Memo

Subject Addendum to the Stormwater Management Strategy – No Regional Park Scenario

Date 29 August 2017

Project McPherson PSP

Figure 1. Alternate FUS layout including no regional park and stormwater treatment assets in the south-east corner. Note this layout is in draft form and indicative only.

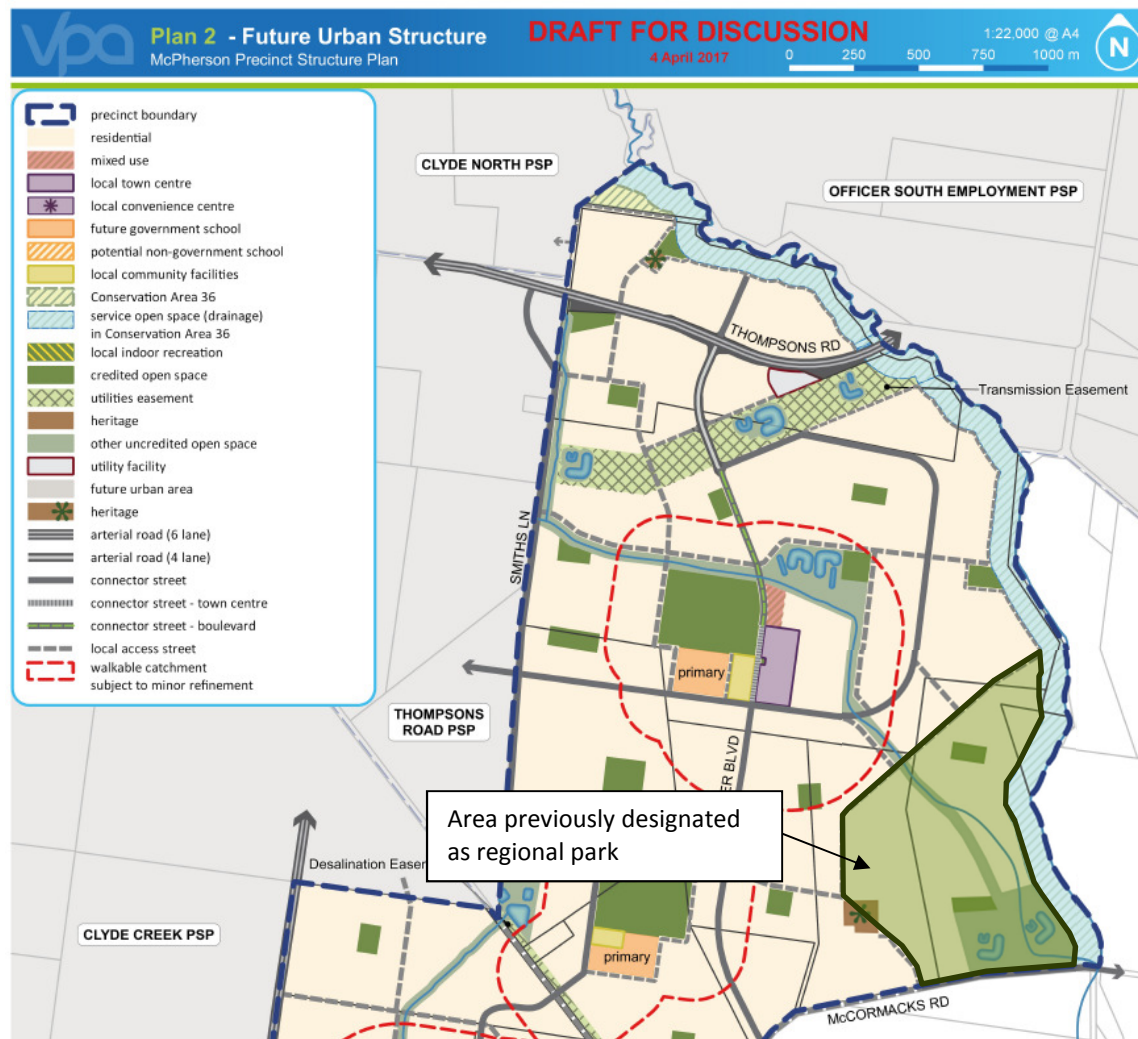
The McPherson PSP occupies approximately 946 ha of land 50 kilometres south east of Melbourne. This addendum to the previous Stormwater Management Strategy (Alluvium 2016) focuses on the northern portion, referred to previously as the Baillieu Creek section. The previous future urban structure (FUS) layout for the Baillieu Creek section featured a large regional park in the south-east corner of the site where the proposed constructed waterway outfalls to Cardinia Creek. An alternate scenario is now considered that removes the regional park and allows for development within its previous footprint. Figure 1 shows the indicative alternate FUS layout. The ultimate location for the regional park is to be determined by DELWP.

The alternate scenario, with replacement of the regional park with expanded development, will increase stormwater-driven pollutant loads outfalling to Cardinia Creek. Further, the location of proposed assets in the regional park site will need to be reconsidered to allow practical drainage from the urban catchment. As such, assets WL_L and WL_K are resized to accommodate the increased load. In this scenario, the updated drainage layout allows asset SB_10 to be consolidated into asset WL_L.

Figure 2. a) Previous draft alignment (suggested by Melbourne Water), b) alignment with sharp curve (current PSP alignment), c) updated splay allowing channel radius of curvature of 75m.

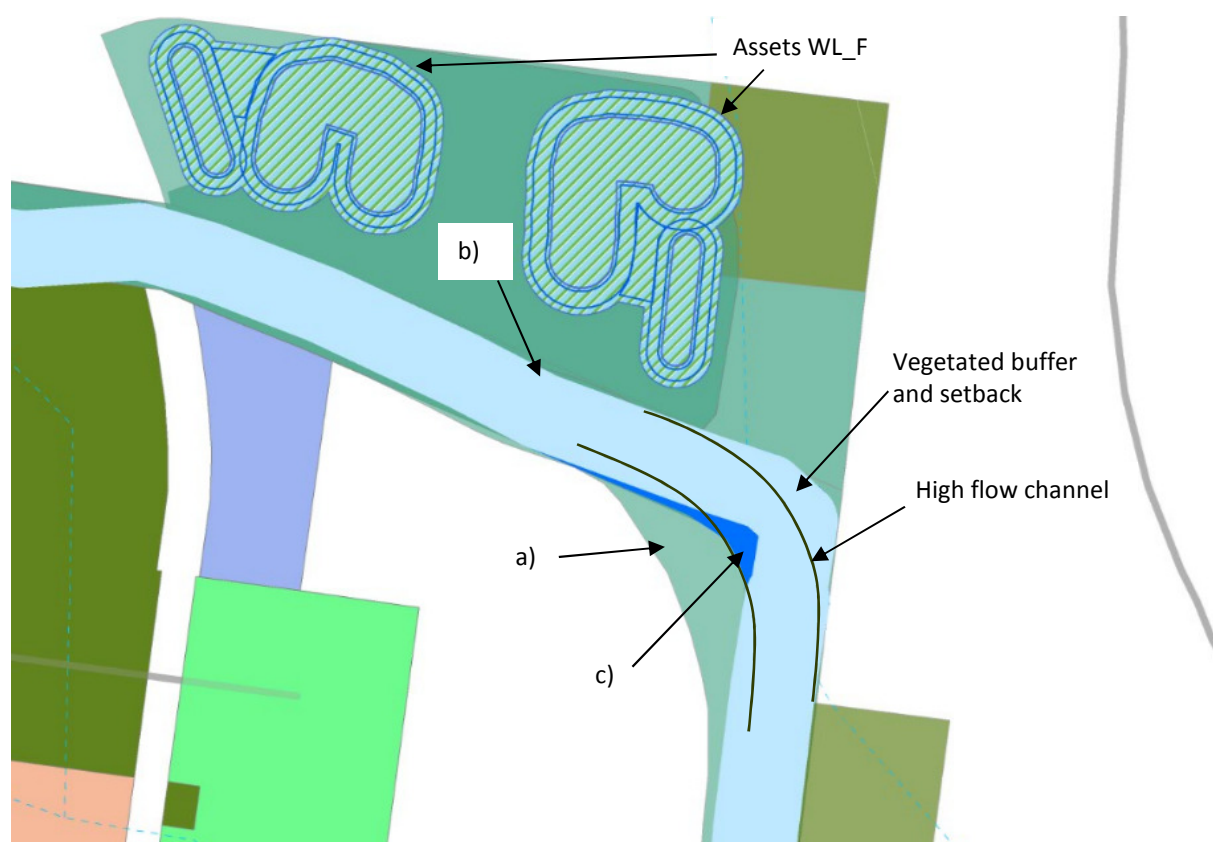
In the original strategy, the constructed waterway in the Baillieu Creek area featured a relatively sharp bend within the 110 Smiths Lane property (see Figure 2). Some concerns were raised by Melbourne Water as to potential high velocities and shear stresses at the location of the bend. Melbourne Water suggested their preference was for a gentler bend in line with previous draft versions of the strategy.

The total constructed waterway corridor includes the core riparian zone and the vegetated buffer in addition to the waterway channel itself. Since constructed waterways are typically designed with some sinuosity in both the low and high flow channels, the actual channel planform can be curved around sharper sections of the total corridor. The proposed waterway corridor at the location of the tight bend has a hydraulic width of 33m. A small splay has been added to the southern boundary of the corridor at this location to allow a radius of curvature of approximately 75m in the high flow channel. The resulting bend sharpness is 2.3, within the acceptable range. Figure 2 demonstrates this arrangement.

Figure 6. Wetlands WL_L and WL_K concept design.

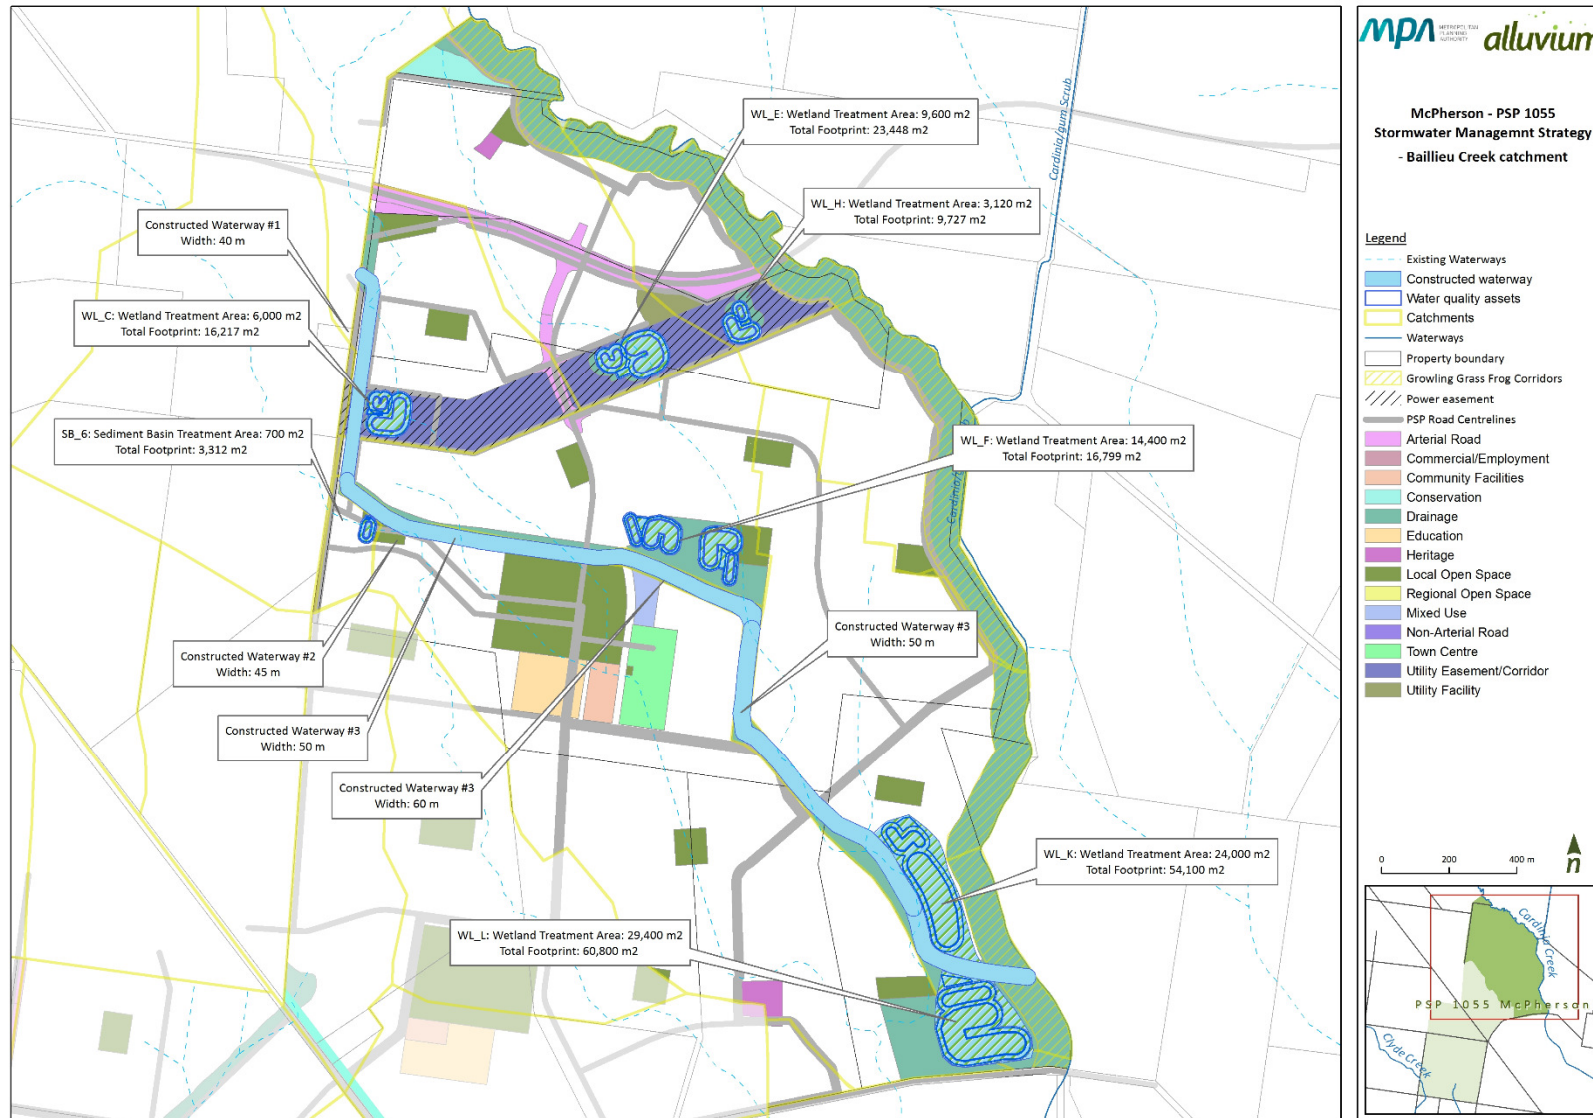
Figure 5 shows the revised strategy maps for the Baillieu Creek section of the PSP, including updated constructed waterway alignment and locations for assets WL_L and WL_K. Figure 6 shows the concept design plans for assets WL_L and WL_K.

The alternate land use scenario was modelled in MUSIC (v6.2.1) to determine the treatment asset size. Table 1 shows the updated wetland design parameters given the alternate land use layout. Wetland velocity calculations and other checks for the updated designs are shown in Table 2 and Table 3 for assets WL_L and WL_K, respectively.
